# Sample Report

Pool Barrier Compliance Report (Victoria)

Applicable barrier standard:	Part 9A - Division 2 of the Building Regulations 2018
------------------------------	---

### Non compliant item 1.01

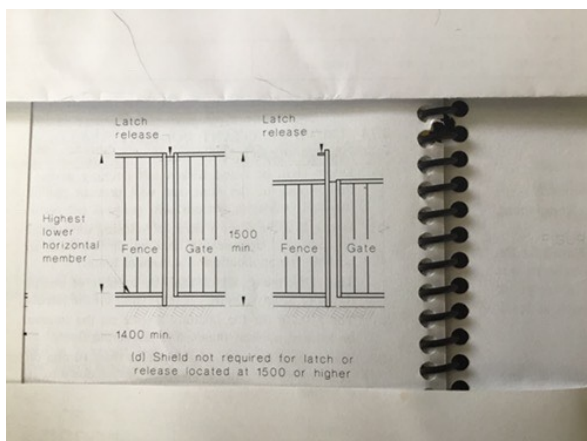
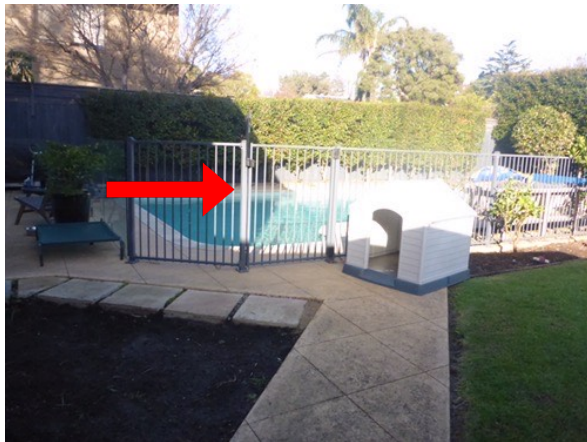
Finding: Barrier gate

The pool barrier gate does function correctly

Pool barrier gates must be self closing and self latching with the gate release mechanism located not less than 1500 mm above floor / ground level

The barrier gate must open away from the pool

Rectification required: The gate will need to be serviced and or rectified in order to comply
